# UNITED STATES PATENT AND TRADEMARK OFFICE

# Office Action Summary

10/507,119

**DETAILED ACTION**

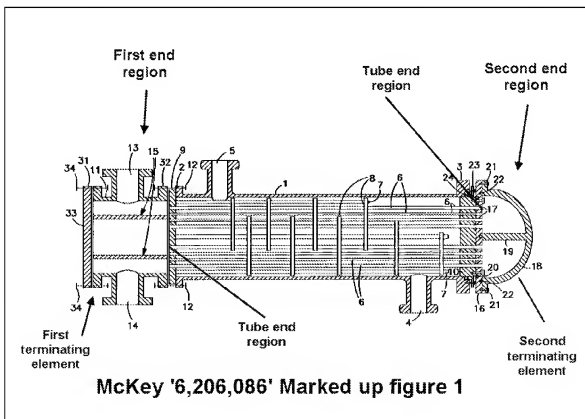
In re claim 23, McKey '086 discloses a heat exchanger (see figure 1) comprising: first (33, figure 1) and second (18, figure 1) terminating elements; at least one tube (6, figure 1) through which a first medium is configured to flow, wherein the at least one tube (6, figure 1) comprises a first end region connected to the first terminating element (see marked up figure 1) and a second end region (see marked up figure 1) connected to the second terminating element (see marked up figure 1); a first tube part (see

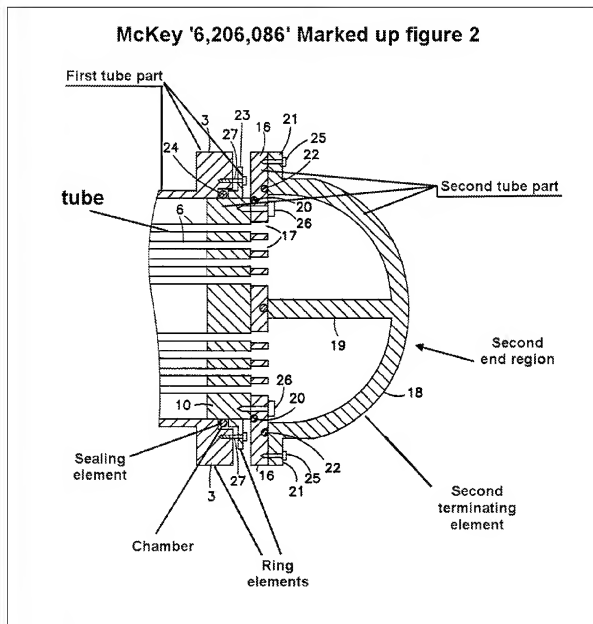
marked up figure 2) connected to the first terminating element (see marked up figure 2); a second tube part (see marked up figure 2) connected to the second terminating element (marked up figure 2), wherein the first and second tube parts (see marked up figure 2) run radially into one another at least over a partial region of their axial extent, wherein one of the first and second tube parts (first tube part, see marked up figure 2) comprises two continuous ring-like elements (see marked up figure 2) protruding radially towards the other of the first and second tube parts (second tube part, see marked up figure 2); and at least one sealing element (24, figure 2, C3, L42-45) disposed between the two ring-like elements in a spatial region between the first and

In re claim 24, McKey '086 discloses the invention above and further discloses that at least one chamber (see marked up figure 2) is formed between the first tube part (see marked up figure 2) and the second tube part (see marked up figure 2) by the two

In re claim 25, McKey '086 discloses the invention above and further discloses that the at least one chamber (see marked up figure 2) is formed by the first tube part (see marked up figure 2) and a second tube part (see marked up figure 2).

In re claim 26, McKey '086 discloses the invention above and further discloses that the chamber is at least substantially sealed off by the two ring-like elements. (See marked up fig. 2).

In re claim 28, McKey '086 discloses the invention above and further discloses that the chamber is at least partially filled with an elastic medium (24, figure 2, packing, C3, L41-45) which comprises the at least one sealing element (see marked up figure 2).

In re claim 34, McKey '086 discloses the invention above and further discloses that the continuous ring- like elements is spaced apart in an axial direction (see marked up figure 2).

In re claim 35, McKey '086 discloses the invention above and further discloses that the continuous ring- like elements form integral constituents of the first tube part (see marked up figure 2).

In re claim 36, McKey '086 discloses the invention above and further discloses that the continuous ring- like elements are additional components connected to the one of the first and second tube parts. (See marked up figure 2 which illustrates that "continuous rings" are considered "additional" components since components are distinctive features to basic design).

In re claim 37, McKey '086 discloses the invention above and further discloses that the continuous ring- like elements serve as support, as seen in a radial direction, for the first and second tube parts. (Please note that ring element (23) is secured with fastener (figure 2), thereby, serves as support between the first and second tube parts.)

In re claim 39, McKey '086 discloses the invention above and further discloses that the at least one tube comprises a plurality of tubes (6, figure 2) through which the first medium flows, wherein the plurality of tubes are arranged substantially parallel to one another radially inside the first and second tube parts. (See marked up figure 2).

Lucke '2,512,748' Marked up figure 4

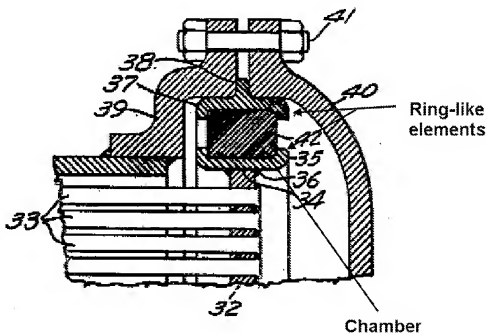
Lucke '748 discloses a chamber not sealed off by the two ring-like elements (See marked up figure 4).

Lucke '748 discloses that the chamber is filled such that the elastic medium forms an annular element (42, C3, L27-30) extending radially between the first and second tube parts. (See marked up figure 4).

Lucke '748 discloses that the at least one sealing element is laid into the chamber as a ring element. (See marked up figure 4, element 42, C3, L27-30 regarding annular rubber body).
